No.DGMS(Tech)(S&T)Circular No.5 of 2002

**Sub:- Anchorage testing of installed roof bolts.**

SKETCH No: DGMS/S&T/2002(A)

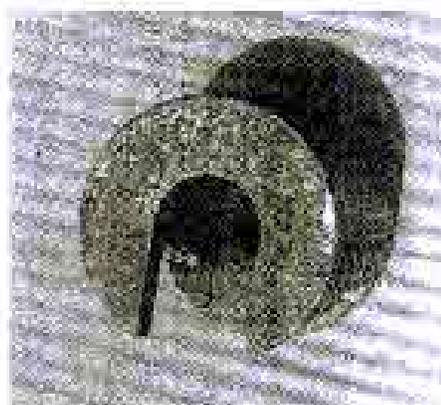
During the course of workshops on “Roof bolting practices” by an officer of this Directorate, who actually visited underground and demonstrated the testing, observed that the design of bridge assembly of anchorage testing machines used by many coal mines is not conducive to proper and smooth testing of installed roof bolts. In certain cases, the results obtained was not that of the grouted bolt, but the strength indicated was the strength of the machine itself, as the inner bridge assembly would sit on the outer bridge. There was no way of knowing the situation in the machine provided. The S&T division of DGMS had worked with the manufacturers and suggested certain improvements, which if complied with, would go a long way in eliminating such wrong results.

Two sketches (DGMS/S&T/2002, A&B) of the modified bridge assembly are enclosed. It is requested that immediate steps are initiated to ensure that no anchorage testing machine is procured unless those are of proper design and the existing defective ones should be modified without delay.
